**From:** Adam Tegen <ategen@manitowoc.org>  
**Sent:** Tuesday, May 5, 2020 3:55 PM  
**To:** Beggs, Tauren R - DNR; Byers, Harris  
**Subject:** RE: SSSAP for Site 3 of Riverpoint District in Manitowoc

**Reference: Site-Specific Sampling and Analysis Plan for Continuance of the Subsurface Investigation Following the Removal of Remaining Structural Impediments and Petroleum Infrastructure  
Riverpoint District – Site 3  
1110 Buffalo Street  
Manitowoc, Wisconsin 54220  
WDNR BRRTS ID: 07-36-583000 (LGU Exemption)  
WDNR BRRTS ID: 03-36-001962 (Closed)**

**From:** Beggs, Tauren R - DNR  
**Sent:** Tuesday, May 5, 2020 3:47 PM  
**To:** 'Byers, Harris'; Adam Tegen  
**Subject:** RE: SSSAP for Site 1 of Riverpoint District in Manitowoc

**Reference: Site-Specific Sampling and Analysis Plan for Continuance of the Subsurface Investigation Following the Removal of Remaining Structural Impediments and Petroleum Infrastructure  
Riverpoint District – Site 1  
200 North 10<sup>th</sup> Street  
Manitowoc, Wisconsin 54220  
WDNR BRTS ID: 07-36-583000 (LGU Exemption)  
WDNR BRTS ID: 02-36-00408 (Closed)**

Figure No. **1**  
**Title**  
**Site Features and Prior and Proposed Post-Slab Removal Sample Locations**

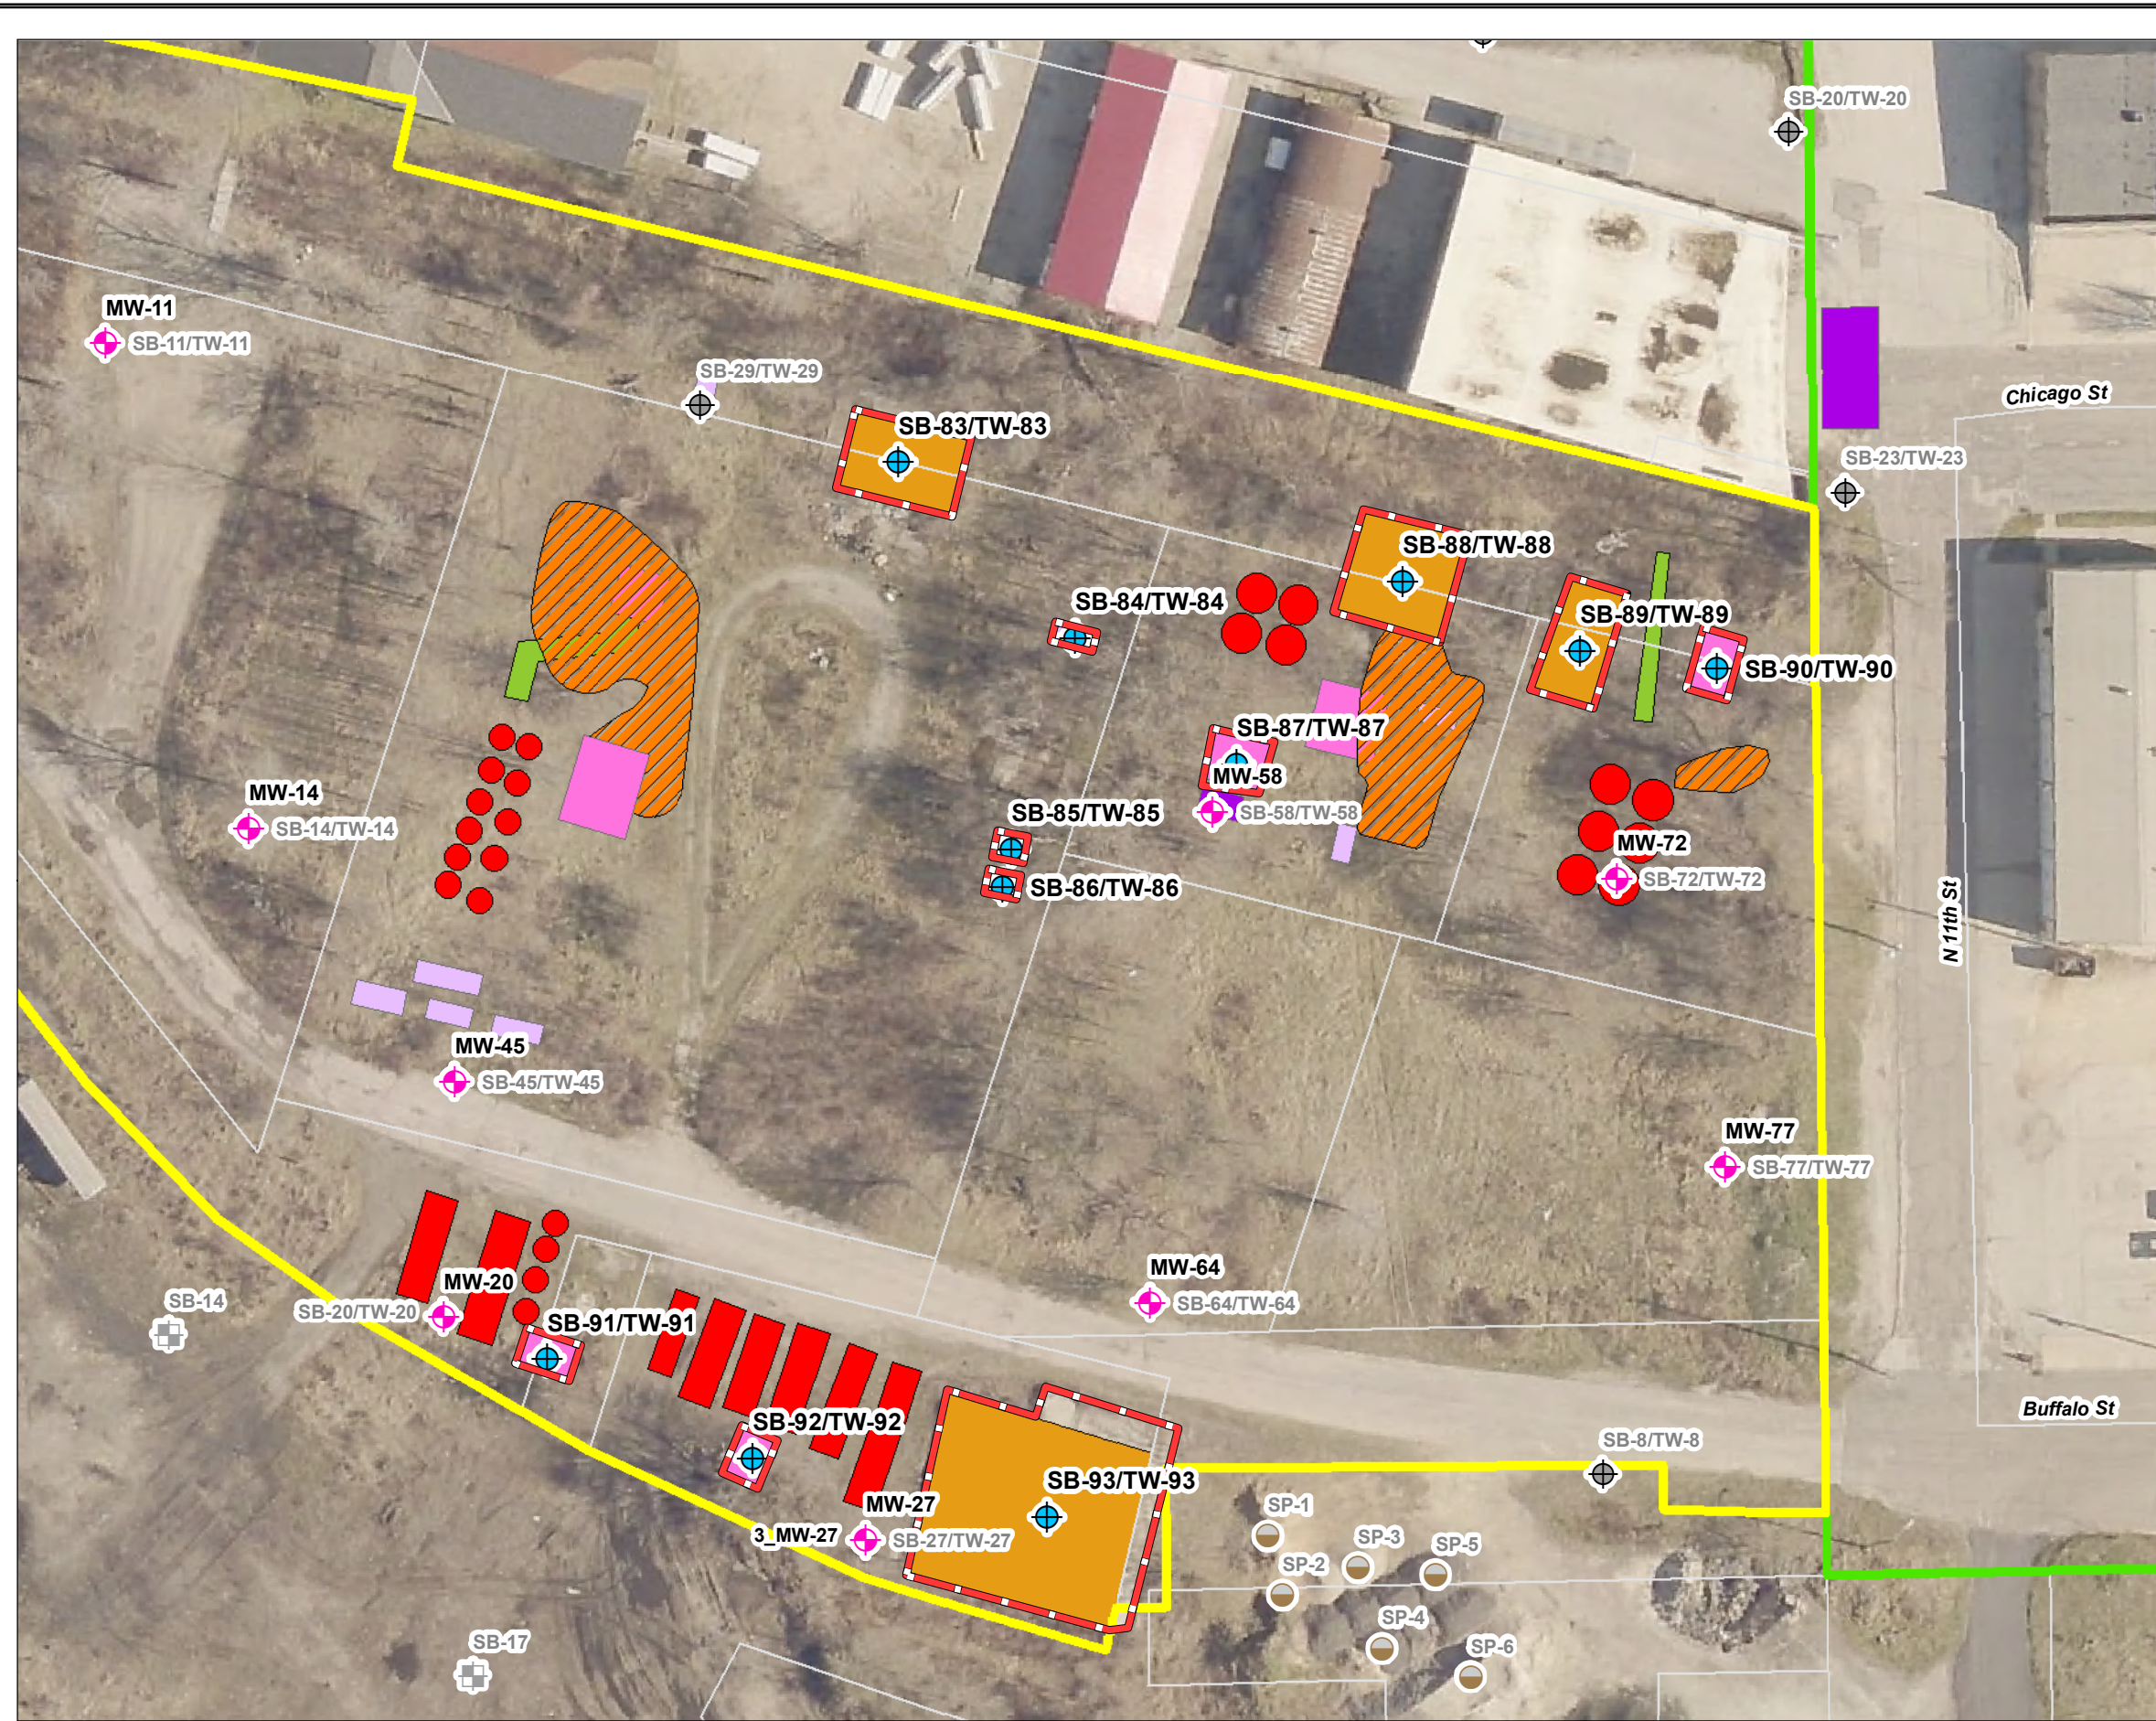
I have completed my review of the SSSAP for the continued investigation of Site 3. This SSSAP seems to be a reasonable approach to assessing areas of Site 3 that couldn't previously be accessed due to slabs still being in place. You could possibly split the difference between SB-85/TW-85 and SB-86/TW-86 with one sampling location since they are in fairly close proximity to each other, but the other locations selected seem to be good for being able to assess if there is contamination under each of the slabs. I don't have any other general comments at this time. These are just general comments I have on the SSSAP; if the City of Manitowoc/Manitowoc CDA (City/CDA) would like a more detailed review and written response/approvals/etc. from the DNR on future documents (example: review of a site investigation report), the City/CDA can submit a technical assistance request on DNR Form [4400-237](#) with applicable fee.

Figure No. **1**  
 Title  
**Site Features and Prior and Proposed Post-Slab Removal Sample Locations**

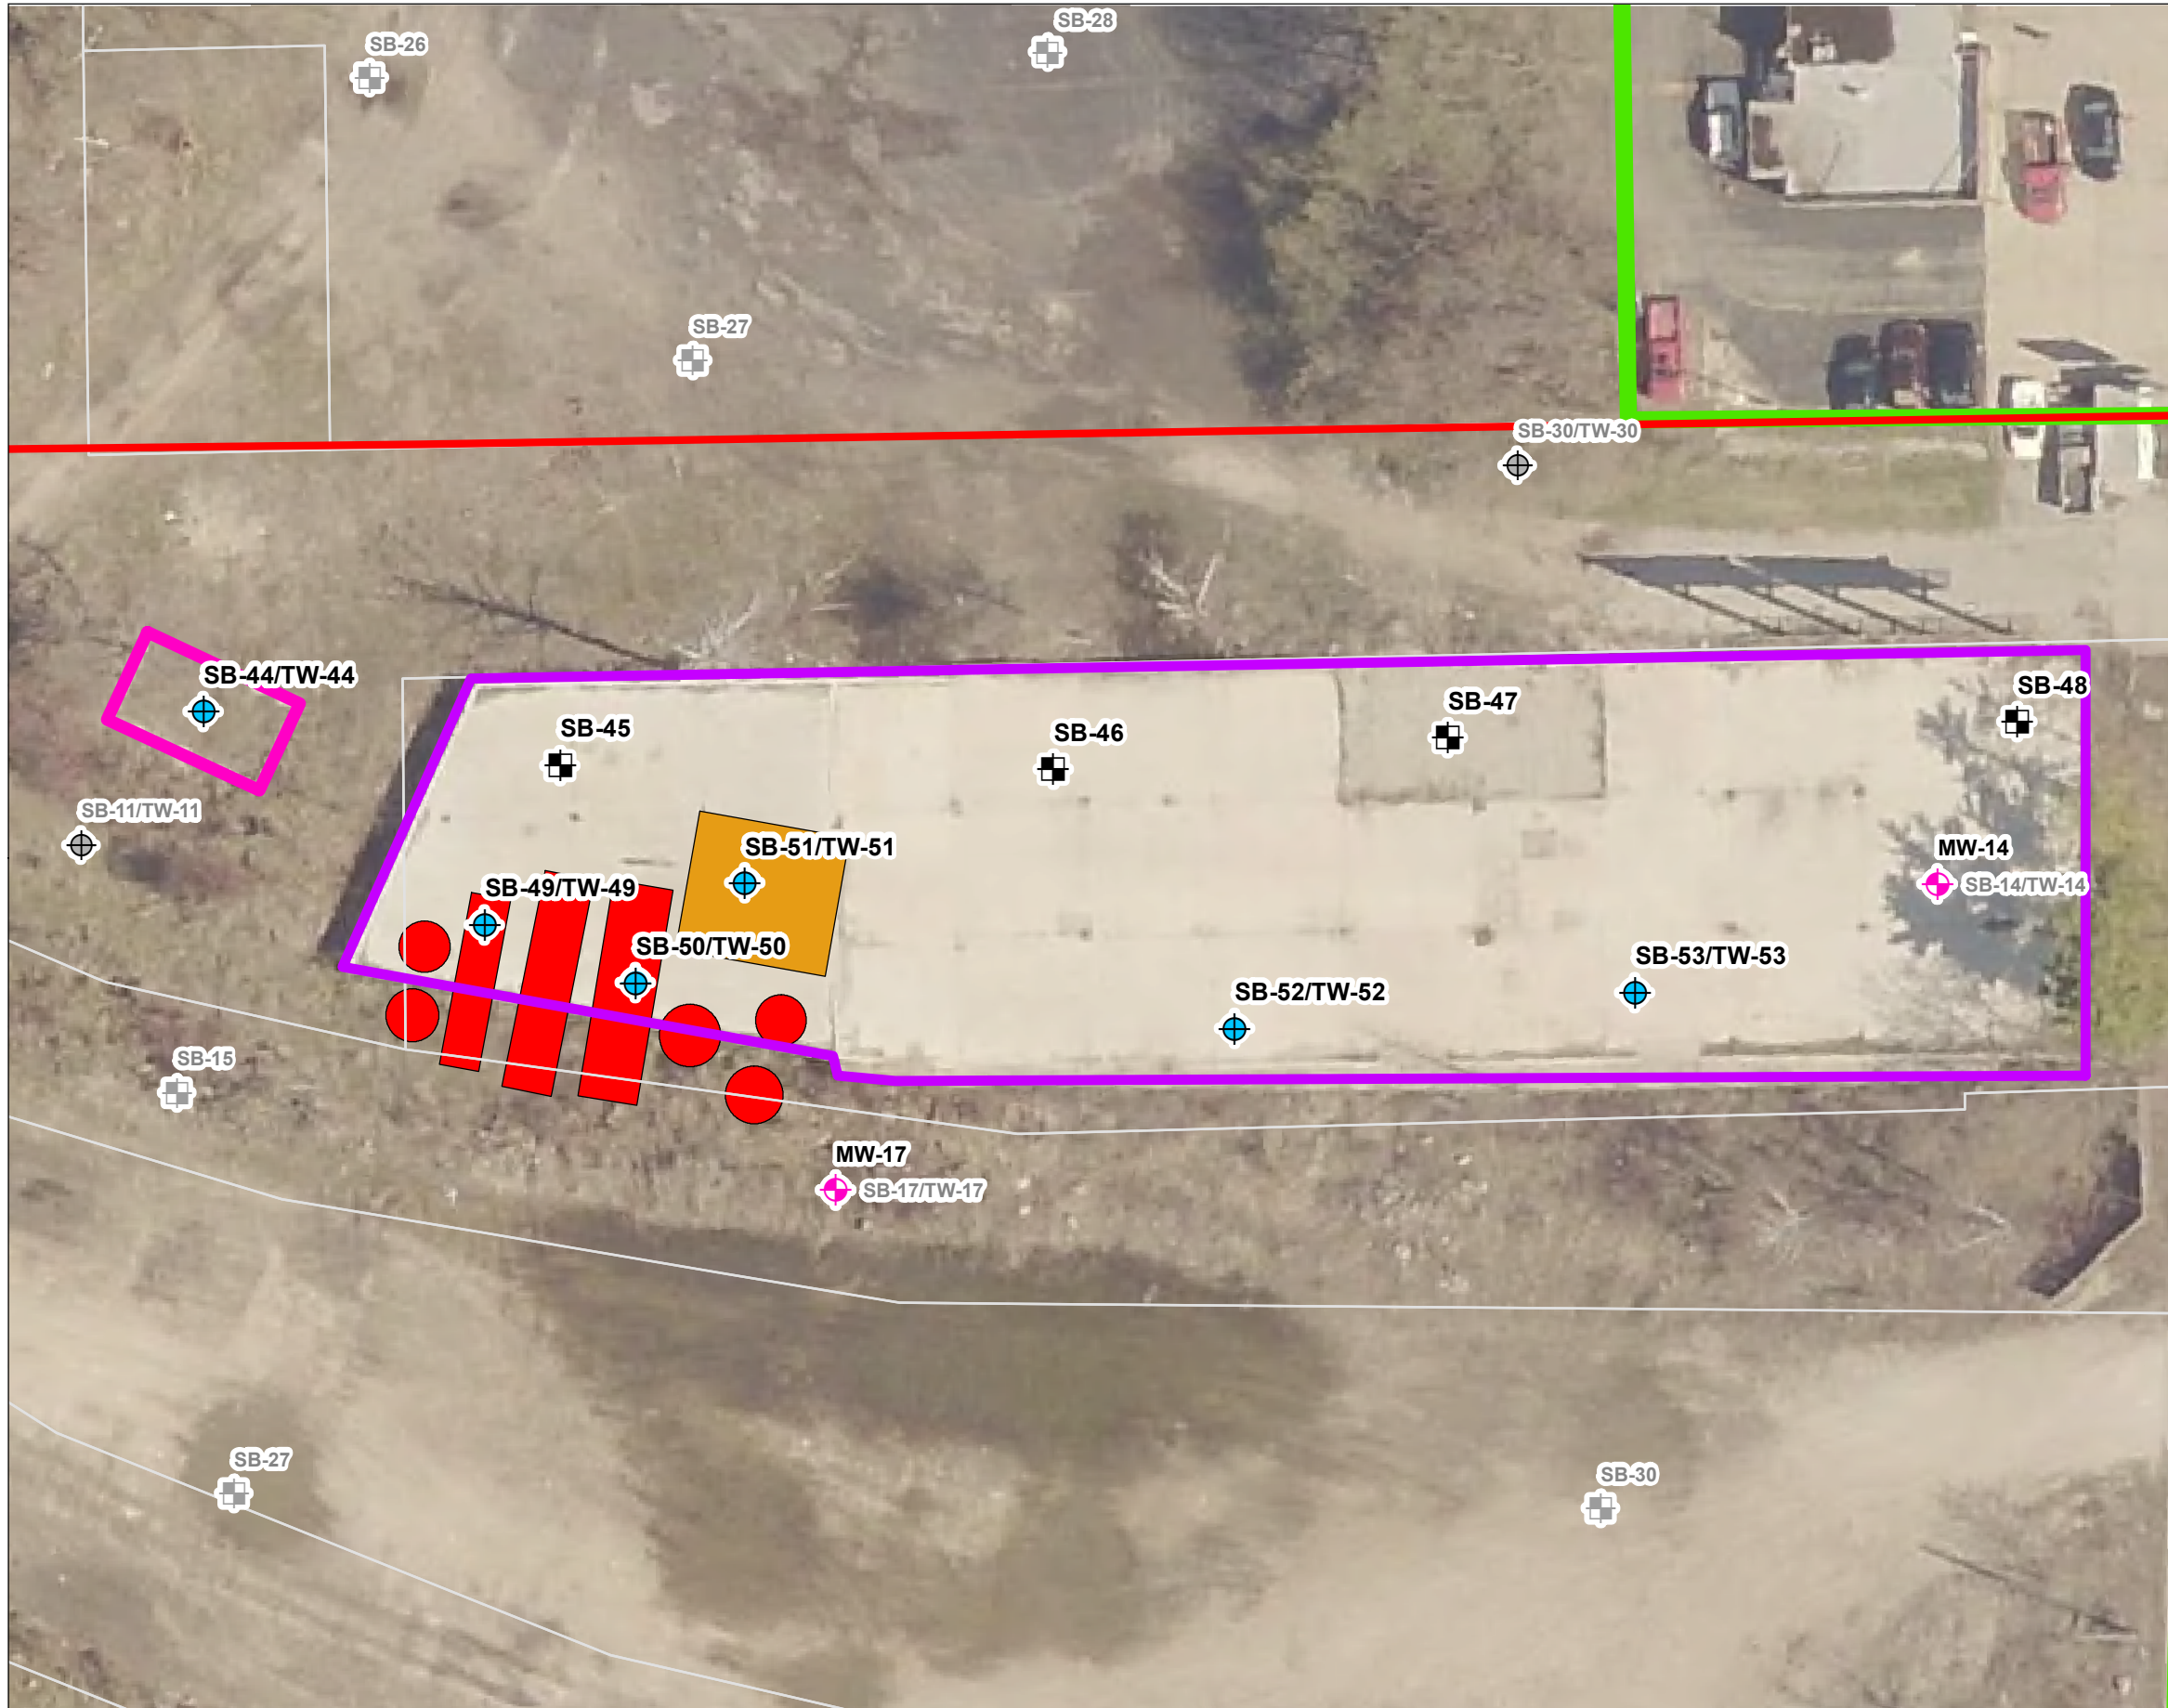
I have completed my review of the SSSAP for the continued investigation of Site 1. This SSSAP seems to be a reasonable approach to assessing areas of Site 1 that couldn't previously be accessed due to slabs still being in place. The contaminants being sampled for and the locations of the samples seem to be appropriate. I don't have any other general comments at this time. These are just general comments I have on the SSSAP; if the City of Manitowoc/Manitowoc CDA (City/CDA) would like a more detailed review and written response/approvals/etc. from the DNR on future documents (example: review of a site investigation report), the City/CDA can submit a technical assistance request on DNR Form [4400-237](#) with applicable fee.
